Access Compliance Report

Public Rights-of-Way

(Curb Ramps)

Intersection ID: 3244	Main Street: CANTERBROOK_DR	Cross Street: WORSLEY_LN	Location: S
ADA ID: 3B0E90F18CDC	Ramp Type: Perp	Initial Pass/Fail: Fail	Overall Compliance: No
		Severity Score: 10

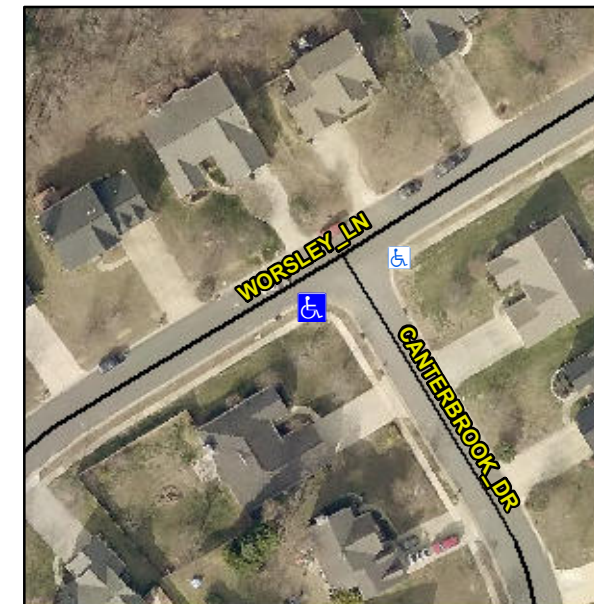
Not Found, R304.5.1, R304.5.3

Compliance	Description	Data	Compliance	Description	Data
N/A	Ramp Length (in)	44.0	Yes	Ramp Slope (%)	5.3
No	Ramp Width (in)	40.0	No	Ramp XSlope (%)	2.1
N/A	Flare Type LT	N/A	N/A	Flare Type RT	N/A
N/A	Flare Slope LT (%)	N/A	N/A	Flare Slope RT (%)	N/A
N/A	Flare Traversable LT?	N/A	N/A	Flare Traversable RT?	N/A
N/A	Landing Length (in)	N/A	N/A	DWS Provided?	N/A
N/A	Landing Width (in)	N/A	N/A	DWS Contrast?	N/A
N/A	Landing Slope (%)	N/A	N/A	DWS Length (in)	N/A
N/A	Landing X Slope (%)	N/A	N/A	DWS Full Width?	N/A
N/A	Landing Curb? (Y/N)	N/A	N/A	DWS Offset (in)	N/A
N/A	Shared Landing?	N/A			
N/A	Gutter Ponding?	N/A	N/A	Gutter Slope (%)	N/A
N/A	Gutter Lip Ht (in)	N/A	N/A	Gutter X Slope (%)	N/A
N/A	Painted X Walk1?	No	N/A	Painted X Walk2?	N/A
	X Walk 1 Direction	To E		X Walk 2 Direction	N/A
N/A	X Walk 1 Width (in)	N/A	N/A	X Walk 2 Width (in)	N/A
	X Walk 1 Slope (%)	2.9		X Walk 2 Slope (%)	N/A
	X Walk 1 X Slope (%)	2.7		X Walk 2 X Slope (%)	N/A

Remove & Replace Entire Ramp.
